Serial: RNP-RA/04-0043

H. B. ROBINSON STEAM ELECTRIC PLANT, UNIT NO. 2
DOCKET NO. 50-261/LICENSE NO. DPR-23

**RESPONSE TO REQUEST FOR ADDITIONAL INFORMATION
FOR RELIEF REQUEST PERTAINING TO EXAMINATION COVERAGE
LESS THAN ESSENTIALLY 100 PERCENT (RELIEF REQUEST NO. 34)**

H. B. ROBINSON STEAM ELECTRIC PLANT, UNIT NO. 2
COVERAGE DATA FOR WELDS 202/01, 202/02, AND 204/A02

COMPONENT ID:	202/01	ASME CATEGORY:	C-A
ASME CODE FIGURE:	IWC-2500-1	ASME ITEM NUMBER:	C1.20
CONFIGURATION:	SHELL TO HEAD	% CRV ACHIEVED:	83.5%
PDI TECHNIQUE USED:	NO	EXAM DATE	4/27/01

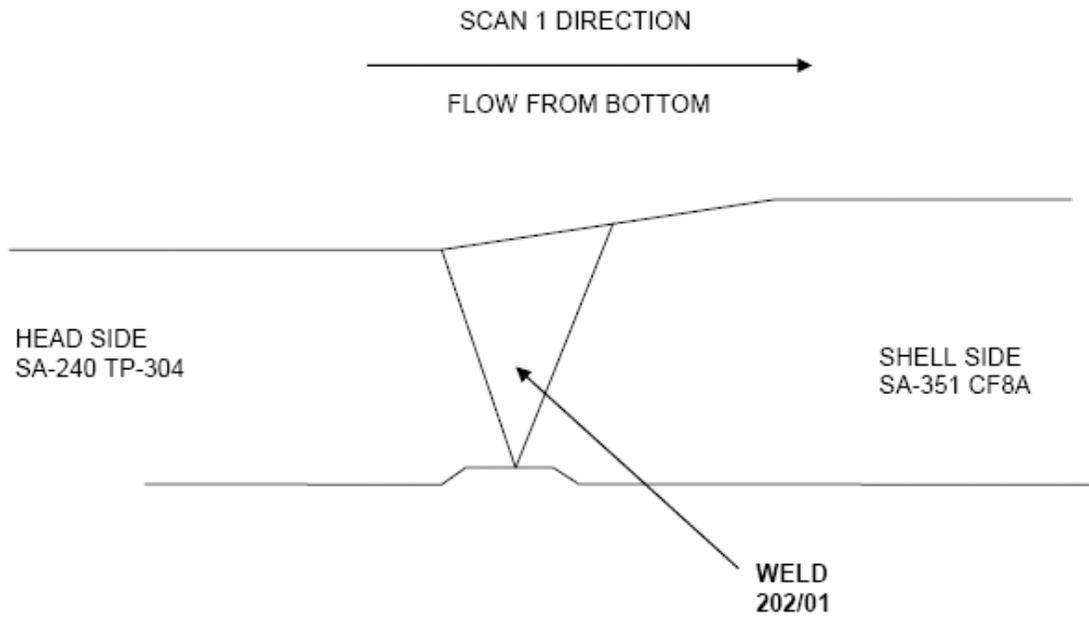
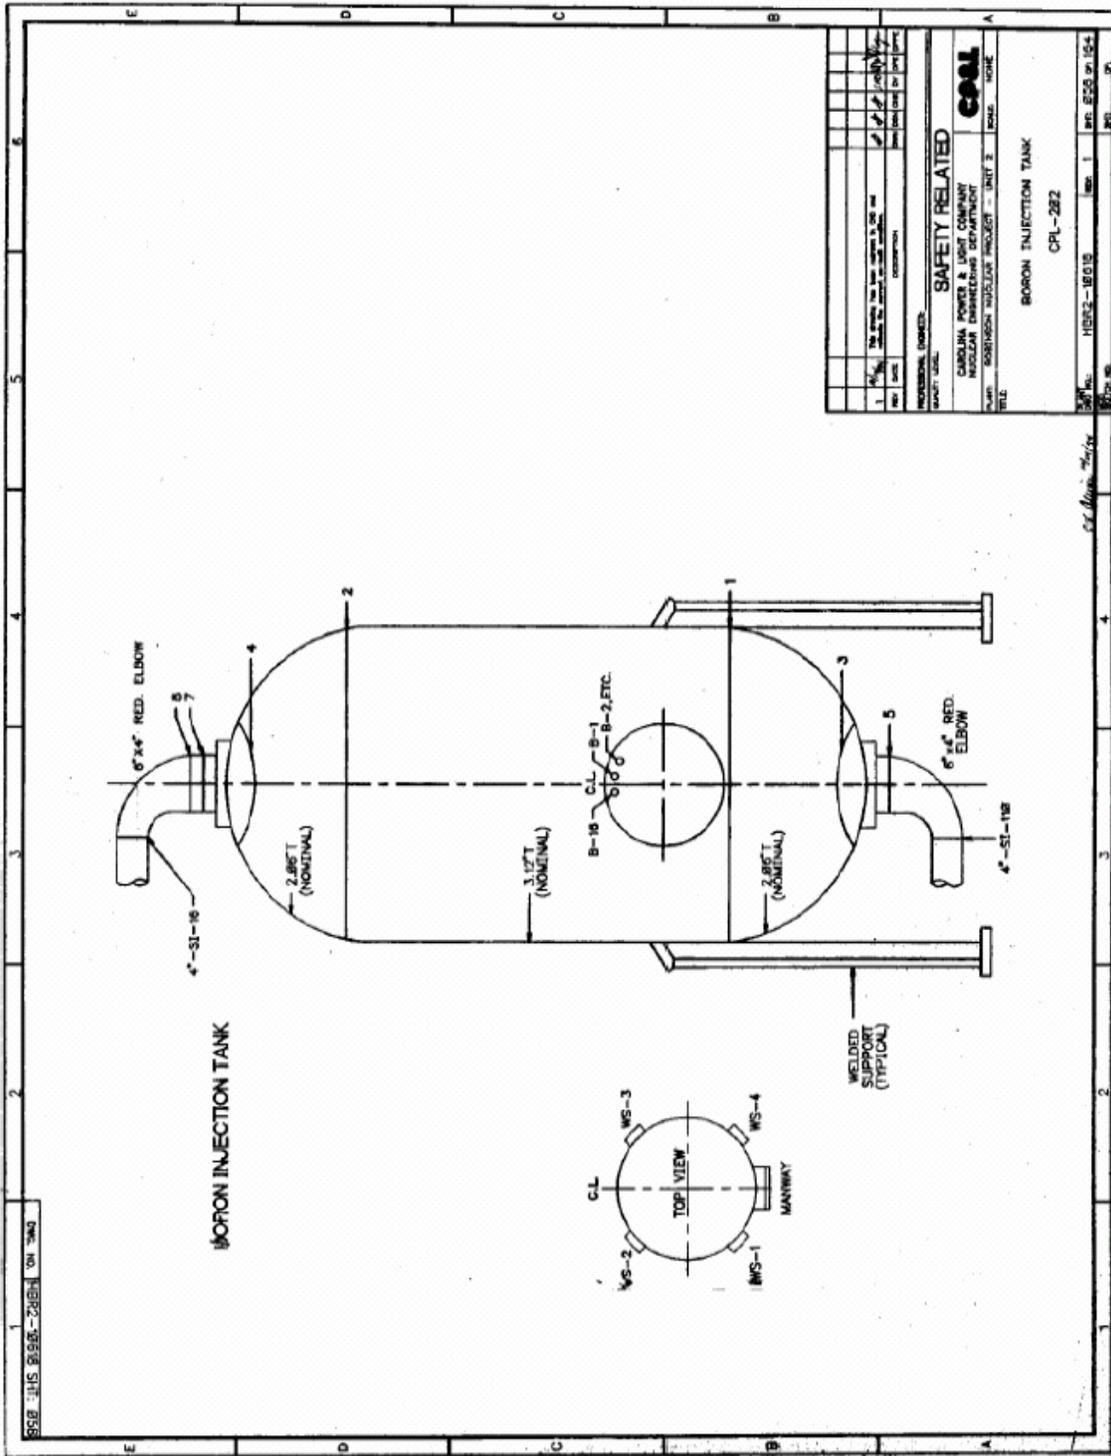
SCAN	% VOLUME ACHIEVED	LIMITATION
1	61%	COMPONENT CONFIGURATION, INSULATION RING AND SUPPORT LEGS
2	73%	COMPONENT CONFIGURATION, INSULATION RING AND SUPPORT LEGS
3	100%	COMPONENT CONFIGURATION, INSULATION RING AND SUPPORT LEGS
4	100%	COMPONENT CONFIGURATION, INSULATION RING AND SUPPORT LEGS

SCAN	% VOLUME ACHIEVED	LIMITATION
1	61%	COMPONENT CONFIGURATION, INSULATION RING AND SUPPORT LEGS
2	73%	COMPONENT CONFIGURATION, INSULATION RING AND SUPPORT LEGS
3	100%	COMPONENT CONFIGURATION, INSULATION RING AND SUPPORT LEGS
4	100%	COMPONENT CONFIGURATION, INSULATION RING AND SUPPORT LEGS

COMPONENT ID:	202/02	ASME CATEGORY:	C-A
ASME CODE FIGURE:	IWC-2500-1	ASME ITEM NUMBER:	C1.20
CONFIGURATION:	SHELL TO UPPER HEAD	% CRV ACHIEVED:	89%
PDI TECHNIQUE USED:	NO	EXAM DATE:	4/27/01

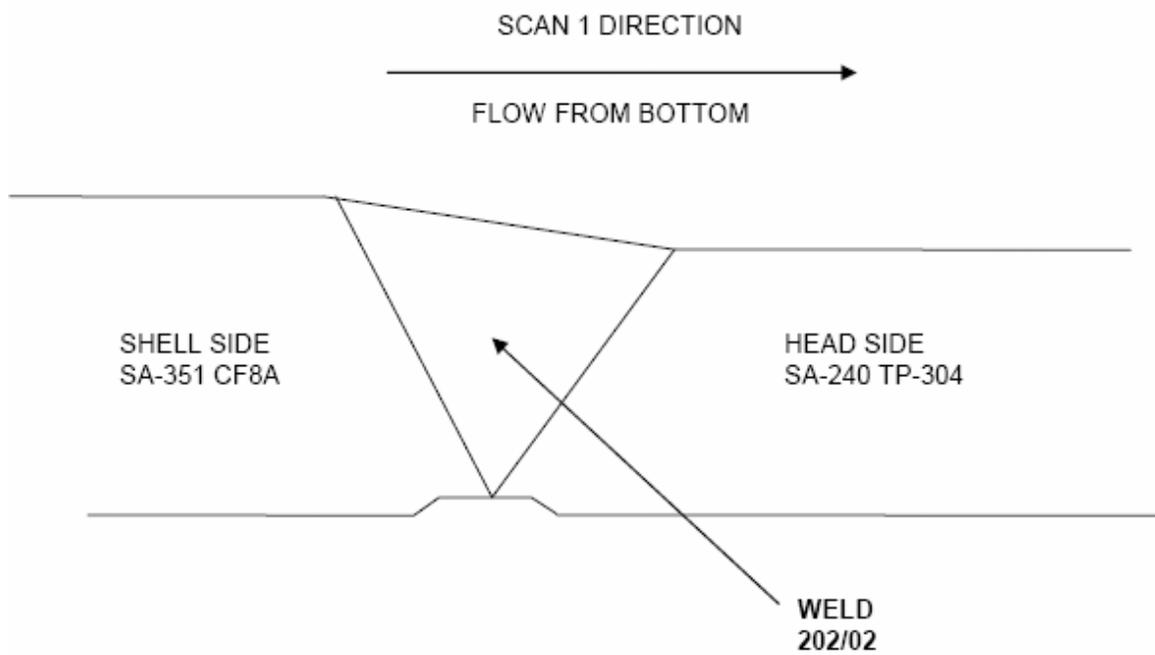
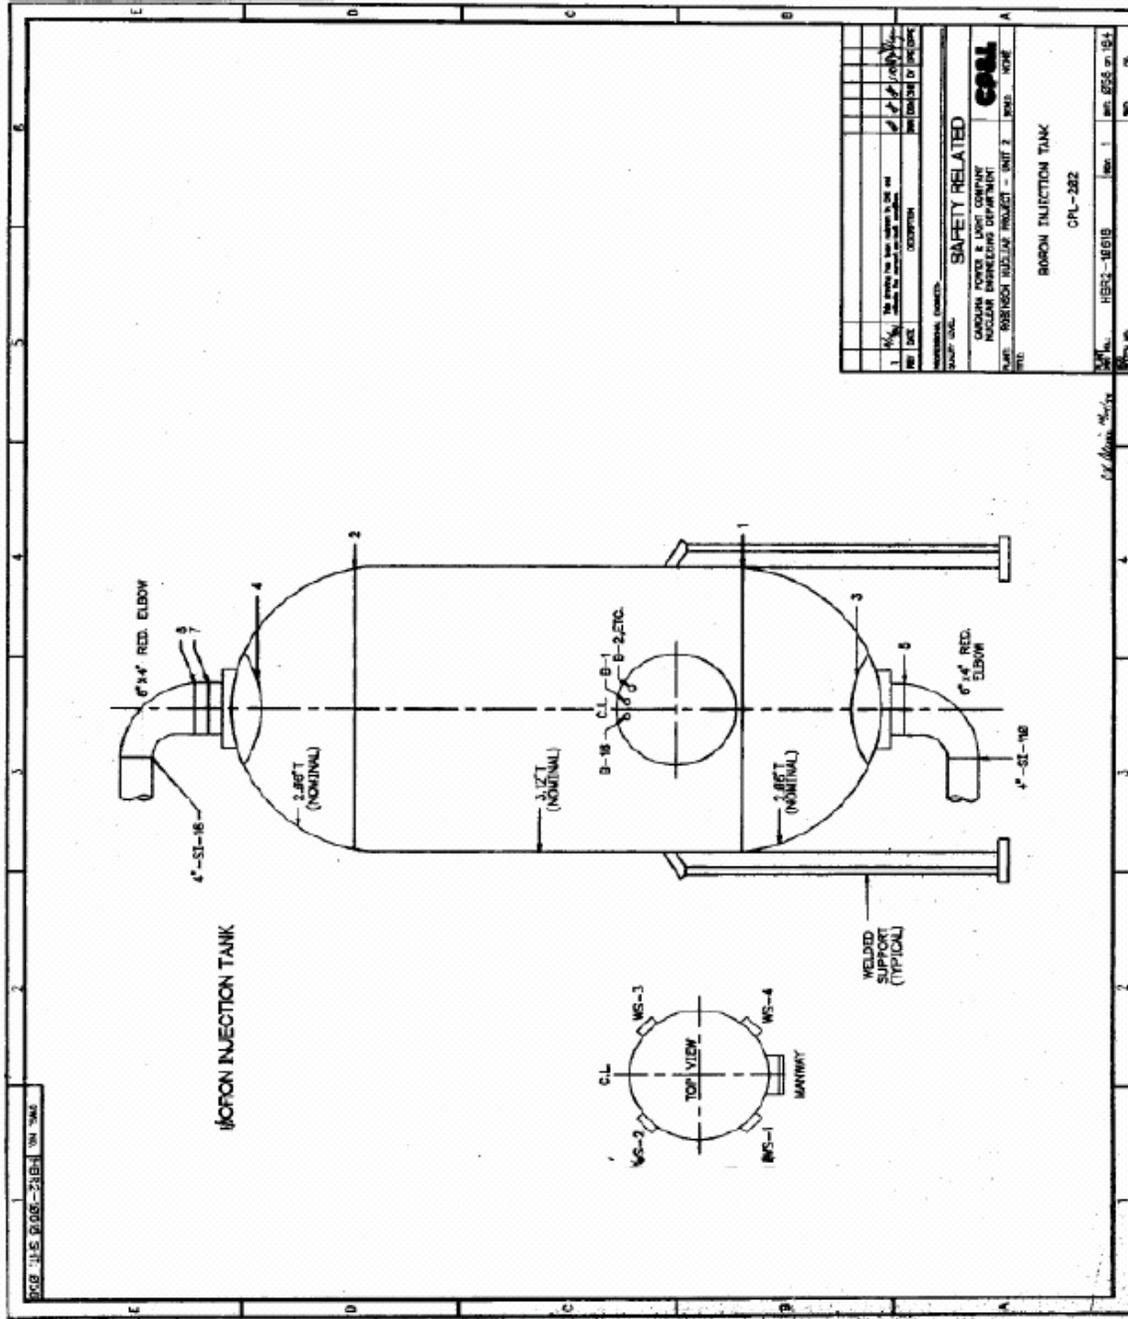
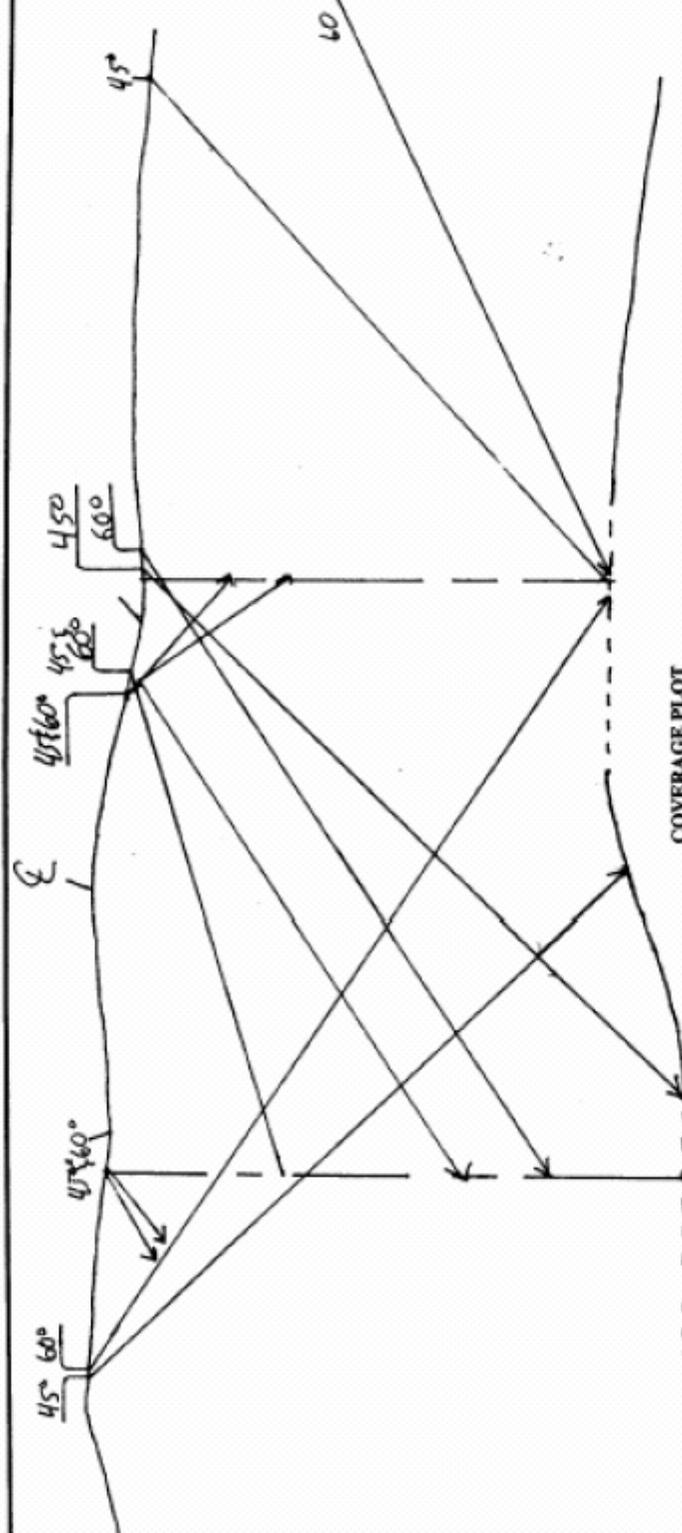
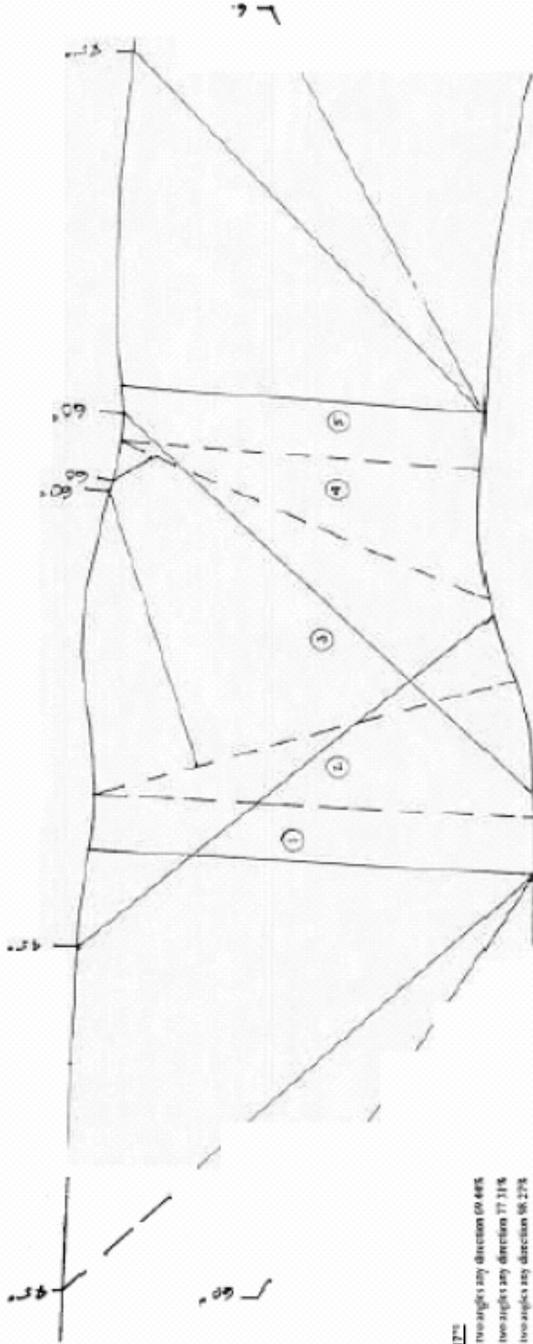
SCAN	% VOLUME ACHIEVED	LIMITATION
1	68%	COMPONENT CONFIGURATION
2	88%	COMPONENT CONFIGURATION
3	100%	COMPONENT CONFIGURATION
4	100%	COMPONENT CONFIGURATION

SCAN	% VOLUME ACHIEVED	LIMITATION
1	68%	COMPONENT CONFIGURATION
2	88%	COMPONENT CONFIGURATION
3	100%	COMPONENT CONFIGURATION
4	100%	COMPONENT CONFIGURATION

SCAN	% VOLUME ACHIEVED	LIMITATION
1	68%	COMPONENT CONFIGURATION
2	88%	COMPONENT CONFIGURATION
3	100%	COMPONENT CONFIGURATION
4	100%	COMPONENT CONFIGURATION

Base Metal = 7.12"
 1) 25° - 4) 180° two angles any direction 69.44%
 2) 167° - 4) 2.16° two angles any direction 77.31%
 4) 1.30° - 4) 1.33° two angles any direction 98.27%
 5) 1.48° - 4) 1.48° two angles any direction 97.30%

448.71% / 5 = 89.74% Total Required Volume Achieved

COMPONENT ID:	204/A02	ASME CATEGORY:	C-A
ASME CODE FIGURE:	IWC-2500-1	ASME ITEM NUMBER:	C1.20
CONFIGURATION:	SHELL TO HEAD	% CRV ACHIEVED:	68.30%
PDI TECHNIQUE USED:	NO	EXAM DATE:	9/30/99

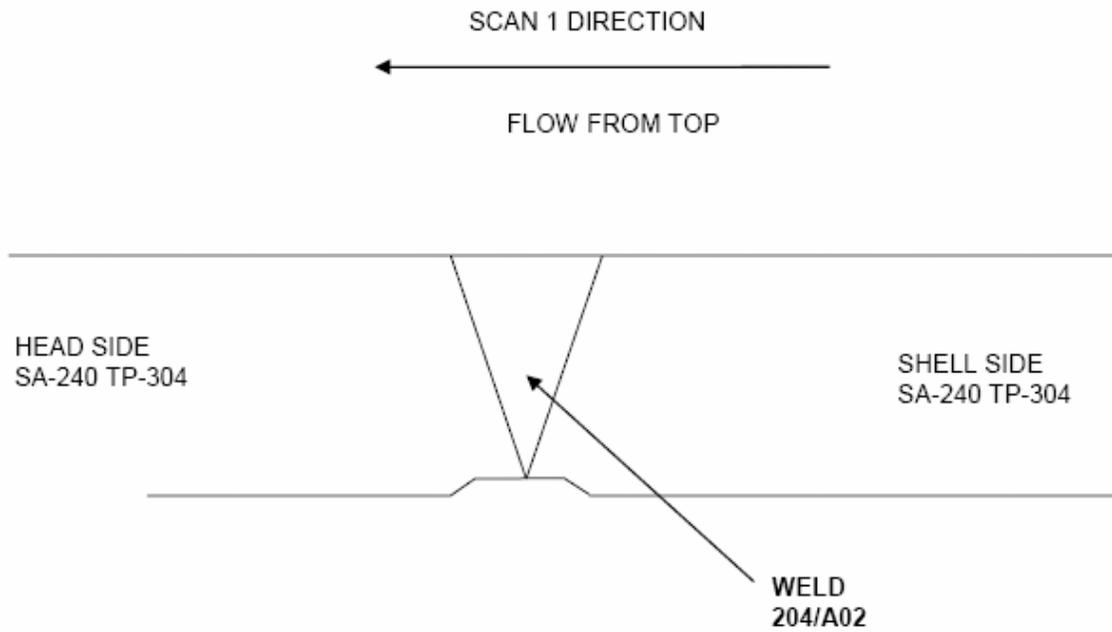
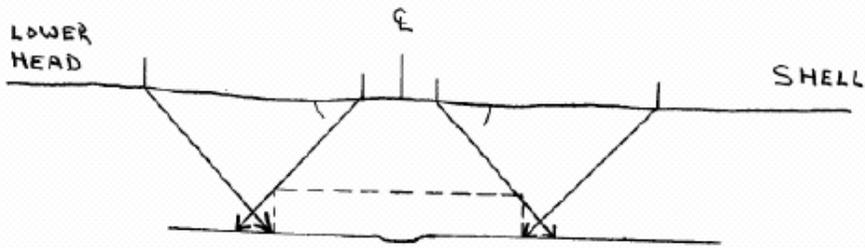
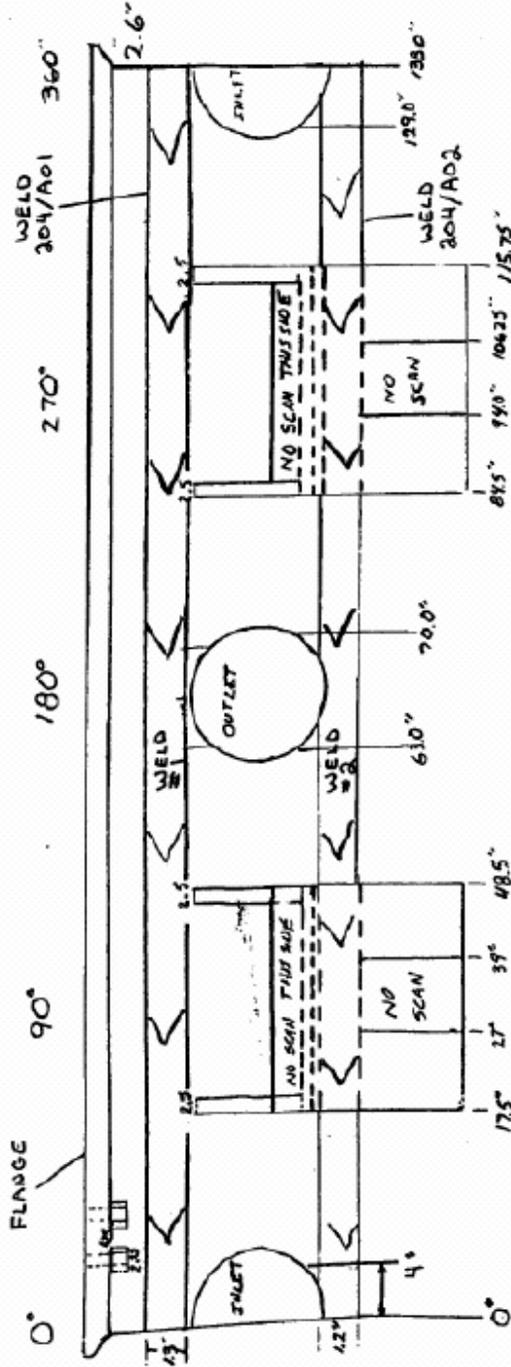
SCAN	% VOLUME ACHIEVED	LIMITATION
1	41%	1/2V DUAL SIDED EXAM PERFORMED. EXAM LIMITED BY NOZZLES (2) AND SUPPORT INTEGRAL ATTACHMENTS (2).
2	80.4%	1/2V DUAL SIDED EXAM PERFORMED. EXAM LIMITED BY NOZZLES (2) AND SUPPORT INTEGRAL ATTACHMENTS (2).
3	75.8%	1/2V DUAL SIDED EXAM PERFORMED. EXAM LIMITED BY NOZZLES (2) AND SUPPORT INTEGRAL ATTACHMENTS (2).
4	75.8%	1/2V DUAL SIDED EXAM PERFORMED. EXAM LIMITED BY NOZZLES (2) AND SUPPORT INTEGRAL ATTACHMENTS (2).

SCAN #1 ABOVE WELD AXIAL SCAN - LIMITATIONS OF 78.25" DUE TO SUPPORT LUGS AND NOZZLES 78.25" ÷ 133" CIRC LENGTH = 59% RESTRICTED OR 41% COVERAGE ACHIEVED

SCAN #2 BELOW WELD AXIAL SCAN - LIMITATIONS OF 24.25" DUE TO SUPPORTS 24.25" ÷ 133" CIRC LENGTH = 18.2% RESTRICTED OR 81.8% COVERAGE ACHIEVED

SCANS #3+4 CIRC SCANS C.W. AND C.C.W. - ABOVE WELD BASE METAL SCAN - LIMITATIONS OF 78.25" DUE TO SUPPORT LUGS AND NOZZLES 78.25" ÷ 133" = 58.8% RESTRICTED OR 41.2% COVERAGE ACHIEVED
 WELD CROWN SCAN - LIMITATIONS OF 24.25" DUE TO SUPPORTS 24.25" ÷ 133" = 18.2% RESTRICTED OR 81.8% COVERAGE ACHIEVED
 BELOW WELD CIRC SCAN ON BASE METAL - LIMITATION OF 24.25" DUE TO SUPPORTS 24.25" ÷ 133" = 18.2% RESTRICTED OR 81.8% COVERAGE ACHIEVED.

SCAN #1 - 41%
 SCAN #2 - 80.4%
 SCAN #3 - 75.8%
 SCAN #4 - 75.8%
 $273 \div 4 = 68.3\%$ CRV WAS ACHIEVED
